Docket Number:	16-AFC-01C
Project Title:	Stanton Energy Reliability Center - Compliance
TN #:	232811
Document Title:	Stanton Energy Reliability Center - Compliance
Description:	The project owner proposes to use an additional 0.71-acre offsite for the use of temporary construction laydown and staging, parking, and temporary offices.
Filer:	John Heiser
Organization:	California Energy Commission
Submitter Role:	Commission Staff
Submission Date:	4/22/2020 7:21:48 AM
Docketed Date:	4/22/2020

STATEMENT OF STAFF APPROVAL OF POST CERTIFICATION CHANGE STANTON ENERGY RELIABILITY CENTER (16-AFC-01C)

Locations of Proposed Offsite Areas

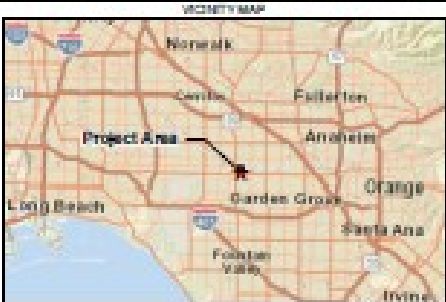
Area A - consists of an approximately 0.24-acre parking area located off of Fern Avenue. This area would be used for worker parking and is currently a parking lot.

Area B – is a corrugated metal-clad warehouse within the same assessor’s parcel as Area A. It would be used for warehousing/laydown.

Area C – is an existing industrial office building, warehouse, and parking lot. The project owner proposes to use approximately one half of the building, the parking lot between the building and Standustrial Street, and the open lot area between the building and the adjacent building to the east. This property would be used for offices, parking, and warehousing/laydown. A gate presently located at the southeast corner of the open lot area of the fenced property would be moved to a more central location along the fence line to enable access to the previously approved SCE laydown area (TN: 228809) located to the south of Area C.

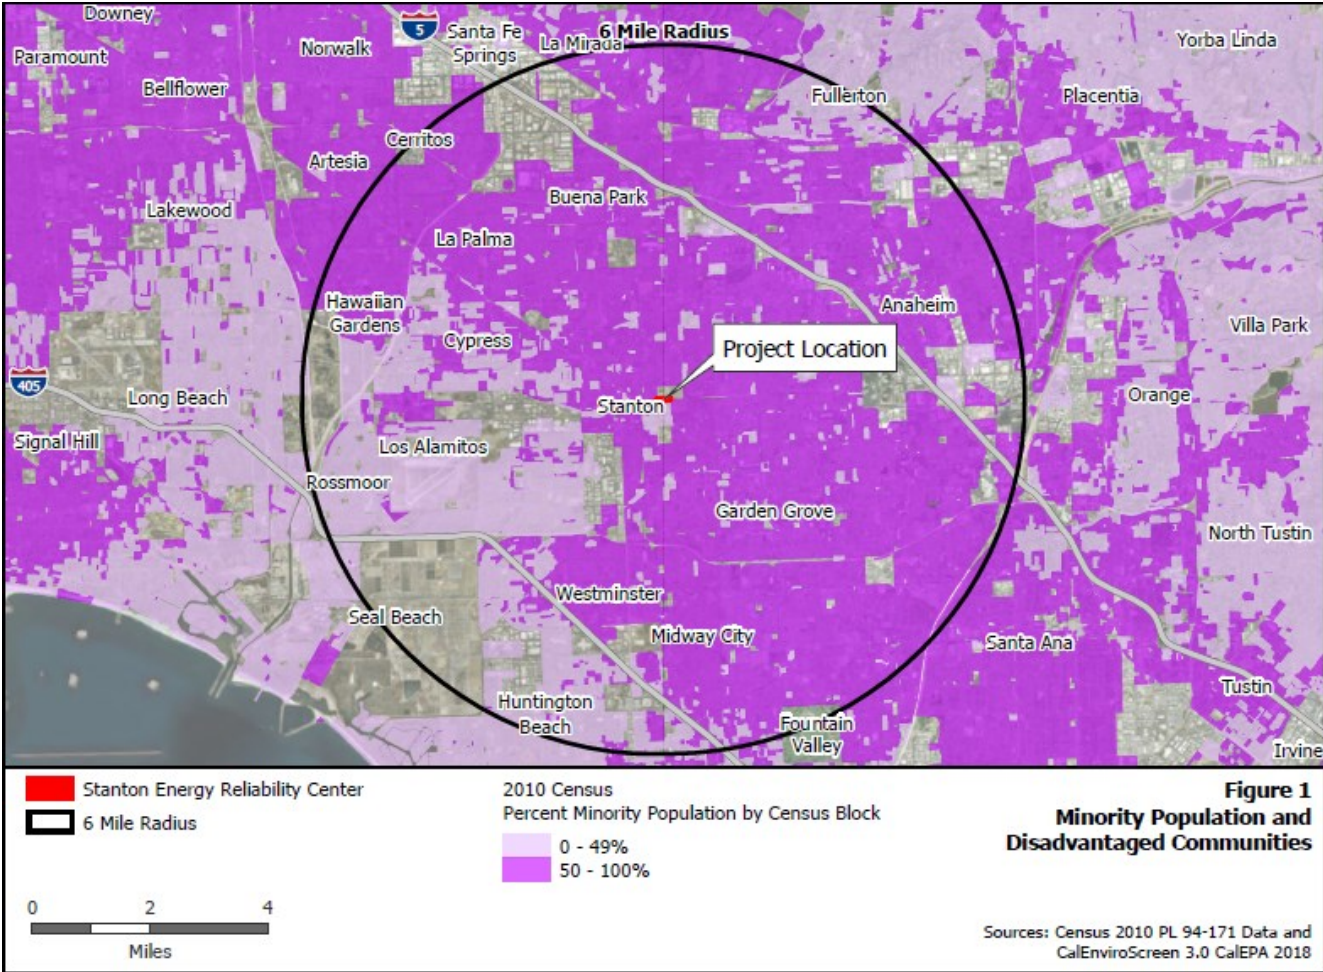
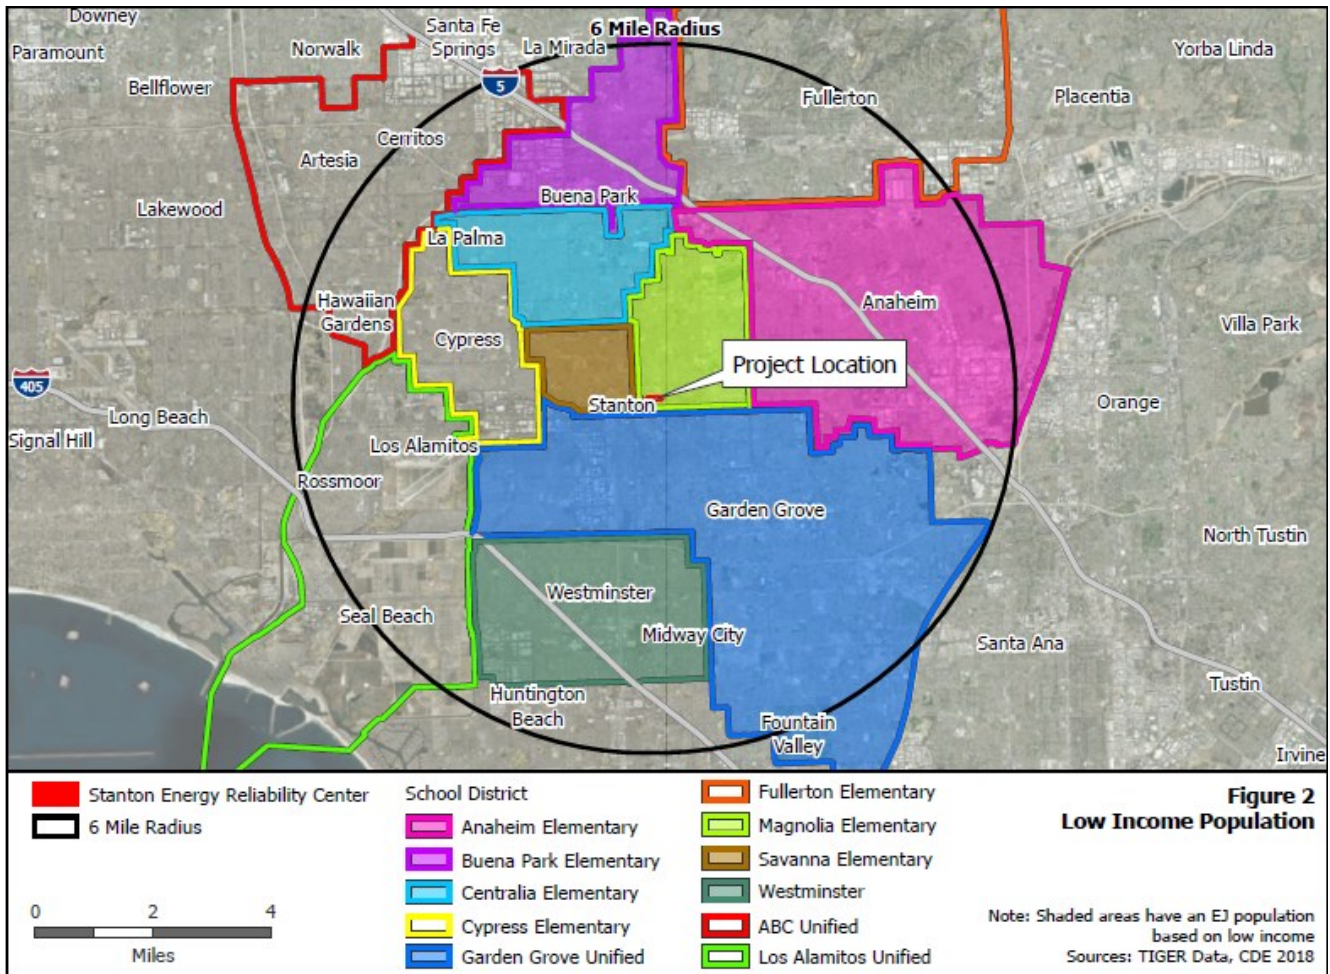
Environmental Justice Figure 1 shows 2010 census blocks in the six-mile radius of the SERC project site with a minority population greater than or equal to 50 percent. The population in these census blocks represents an environmental justice (EJ) population based on race and ethnicity as defined in the United States Environmental Protection Agency's *Guidance on Considering Environmental Justice During the Development of Regulatory Actions*. Staff conservatively obtains demographic data within a six-mile radius around a project site based on the parameters for dispersion modeling used in staff's air quality analysis. Air quality impacts are generally the type of project impacts that extend the furthest from a project site. Beyond a six-mile radius, air emissions have either settled out of the air column or mixed with surrounding air to the extent the potential impacts are less than significant. The area of potential impacts would not extend this far from the project site for most other technical areas included in staff's EJ analysis.

For this petition, staff has concluded that the effects in the areas of Air Quality, Noise and Vibration, Socioeconomics, Traffic and Transportation, and Visual Resources would be less than significant, and thus would be less than significant on the EJ population represented in **Environmental Justice Figure 1, Figure 2, and Table 1.**
